**CITY OF LA VISTA
MAYOR AND CITY COUNCIL REPORT
SEPTEMBER 18, 2018 AGENDA**

Subject:	Type:	Submitted By:
APPLICATION FOR PUD SITE PLAN – LOT 1, ROTELLA’S FIRST ADDITION, LOTS 4, 5, 6, 15, 16, 17, AND 28A OAKDALE PARK, AND TAX LOT 8A2 (108 TH ST & HARRISON ST)	◆ RESOLUTION ◆ ORDINANCE RECEIVE/FILE	CHRISTOPHER SOLBERG CITY PLANNER

RE: Rotella's Italian Bakery
Site Development Plan
Proposed Planned Unit Development (PUD) Site Plan - Initial Review

RE: Rotella's Italian Bakery
Site Development Plan
Proposed Planned Unit Development (PUD) Site Plan – 2nd Review

ROTELLA'S ITALIAN BAKERY SKYWALK & WAREHOUSE ADDITION

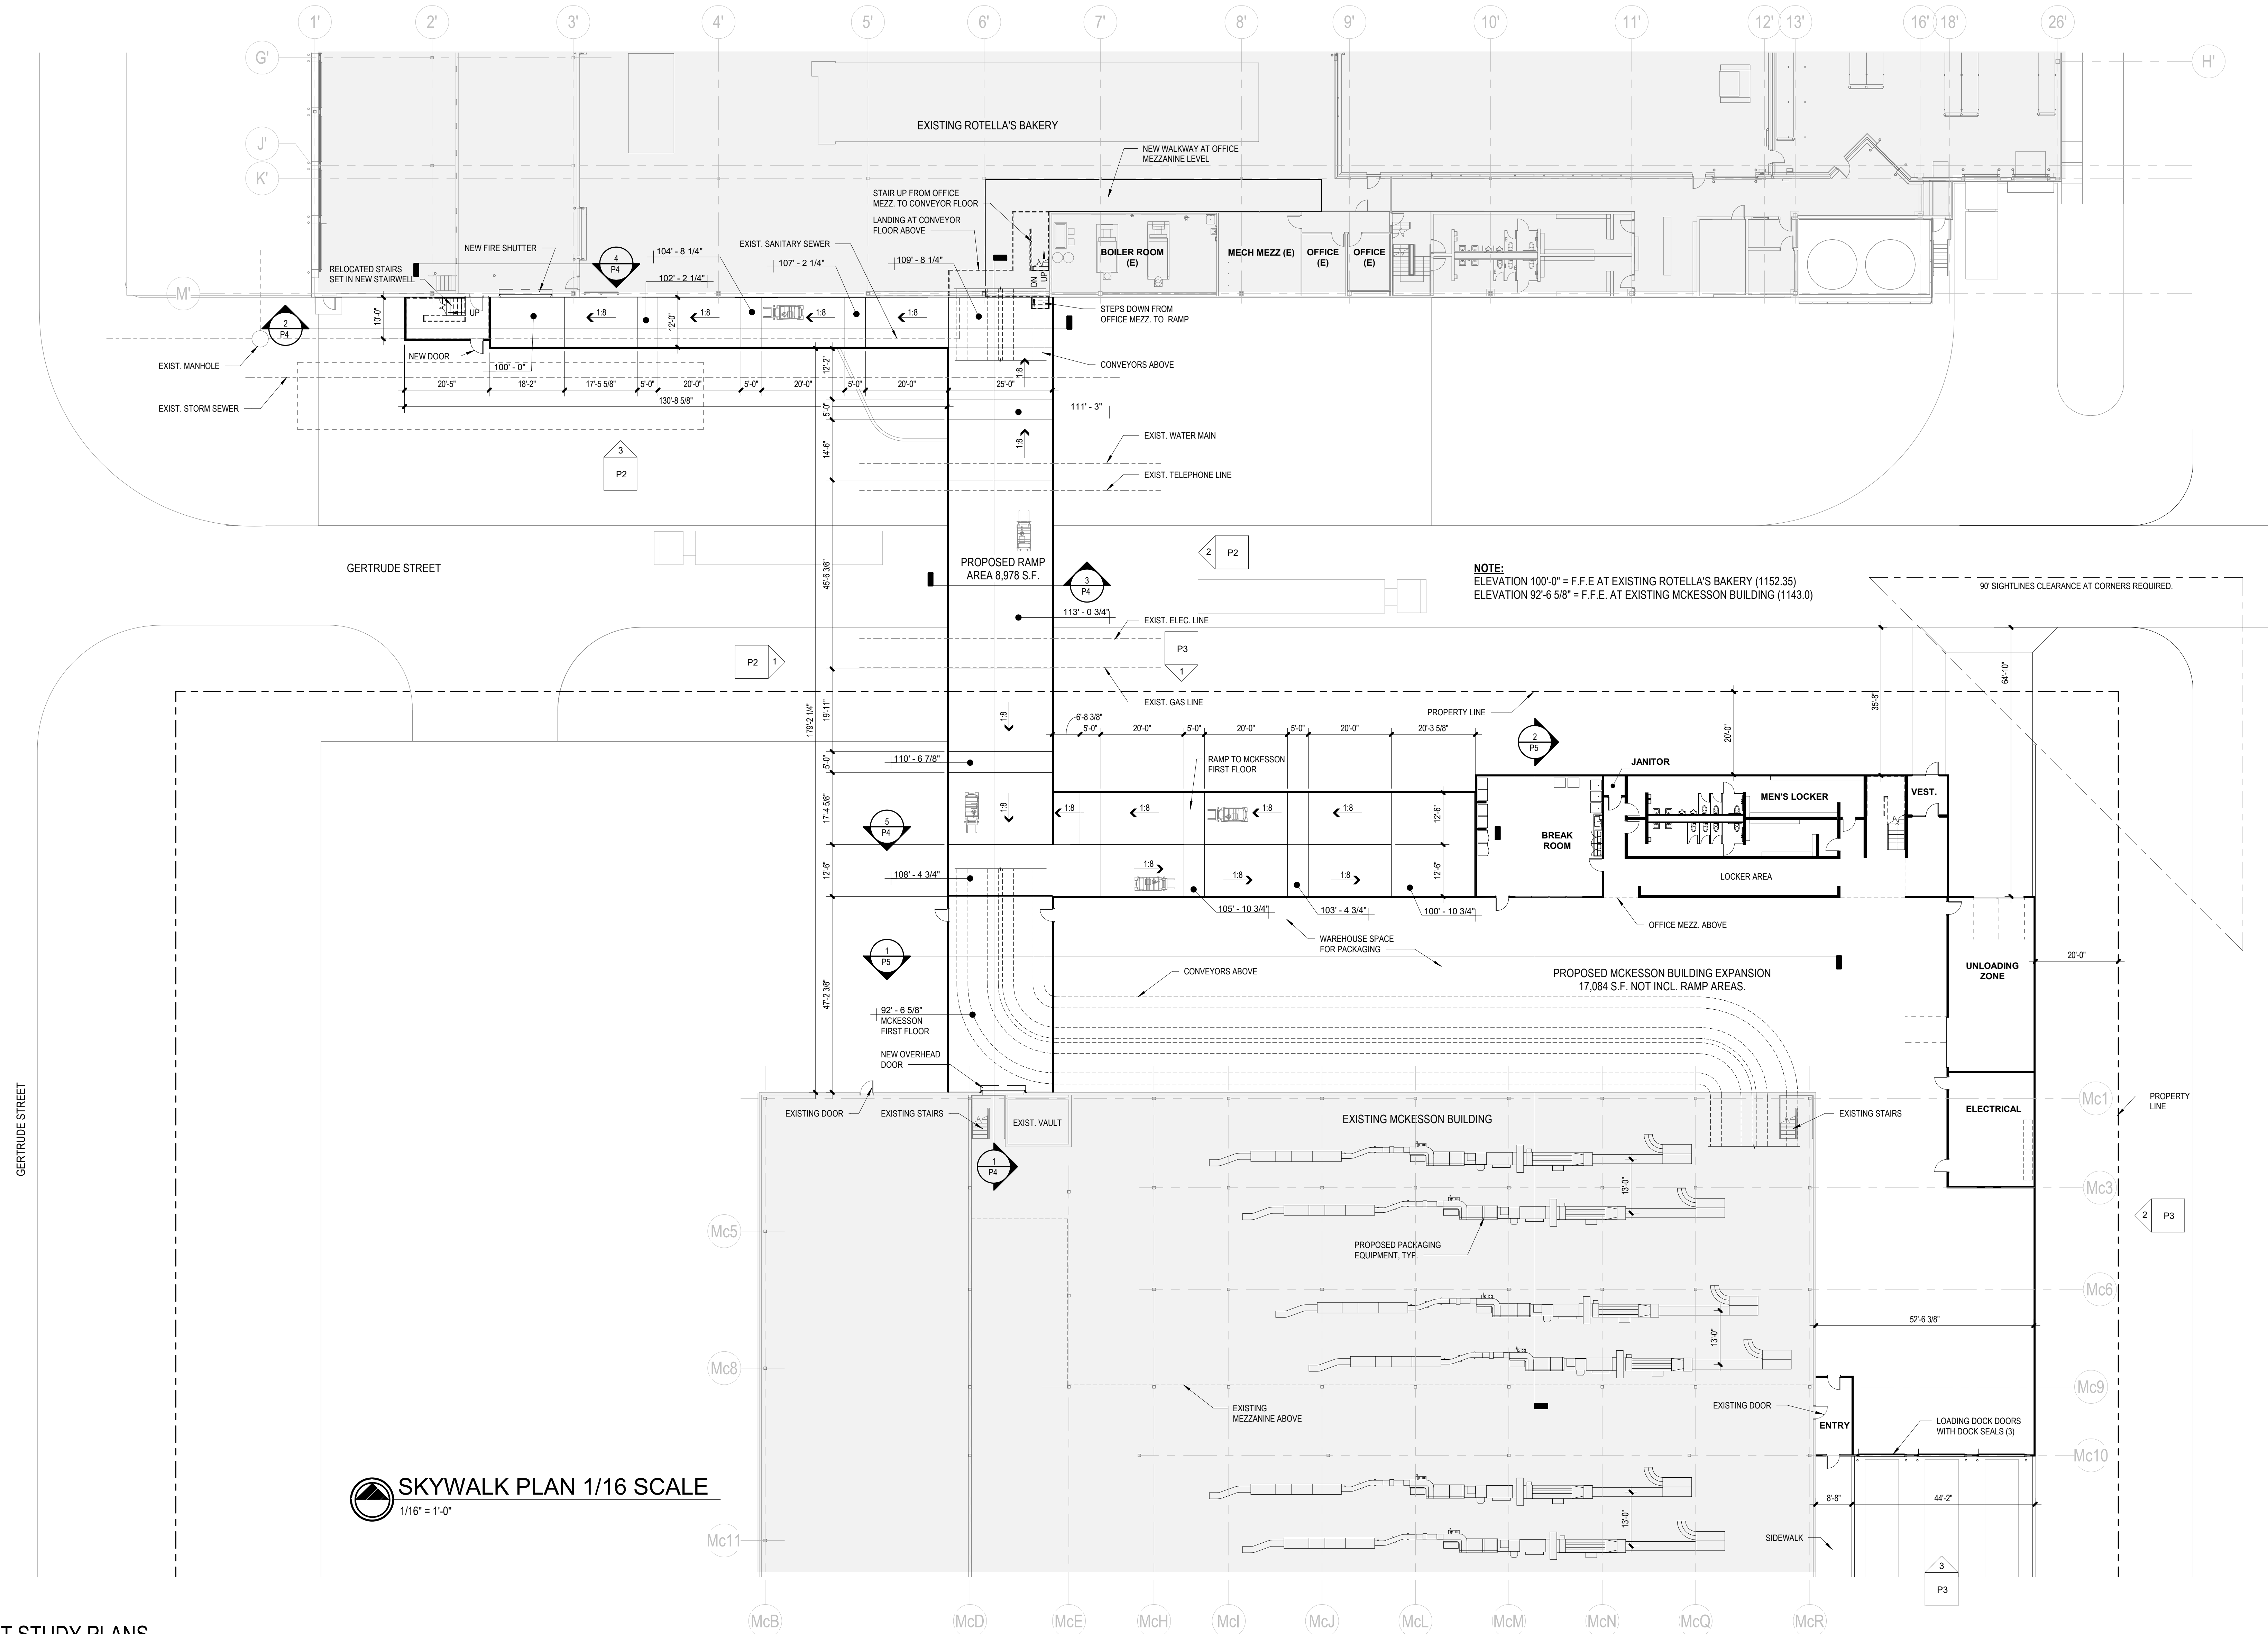
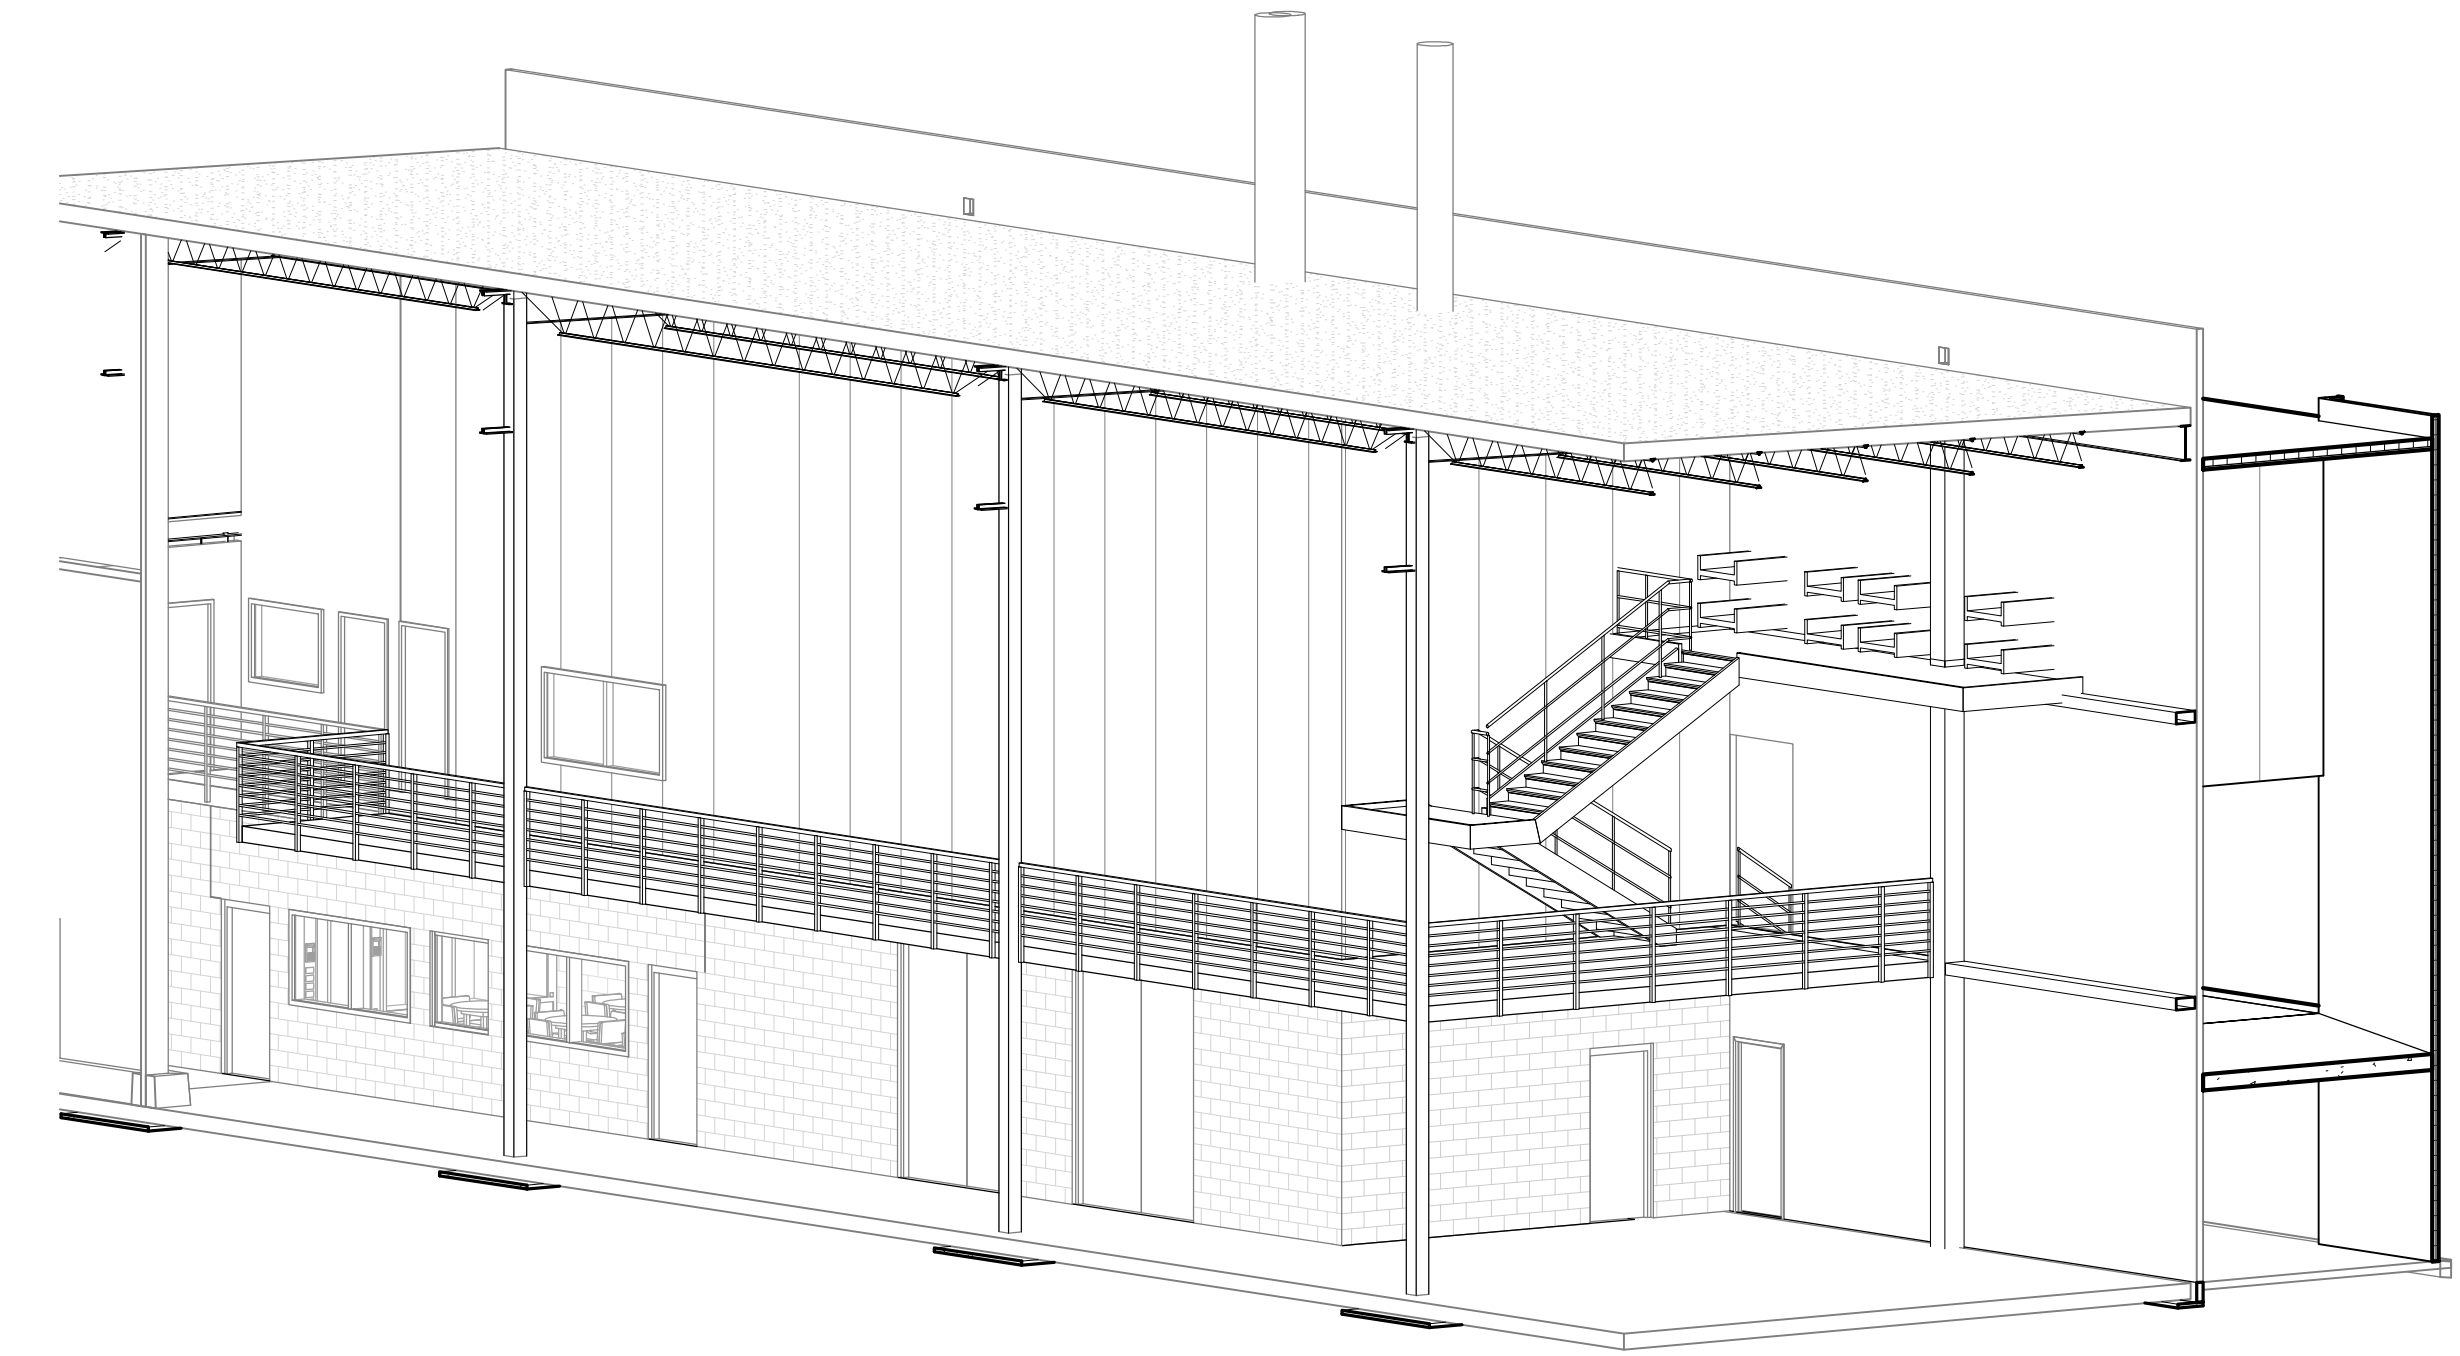
3. A recent conversation with a consultant working for the applicant indicated the possibility of the need to lower Gertrude Street to accommodate the proposed skywalk connection between the Main Plant and the former McKesson Building. If that is being proposed, then that needs to be addressed with this submittal. It is recommended that lowering of this road be avoided, if at all possible.

b. **Comment:** If Gertrude street needs to be lowered to accommodate the future skywalk, then that needs to be addressed with this submittal. It is recommended that lowering the road be avoided if at all possible.
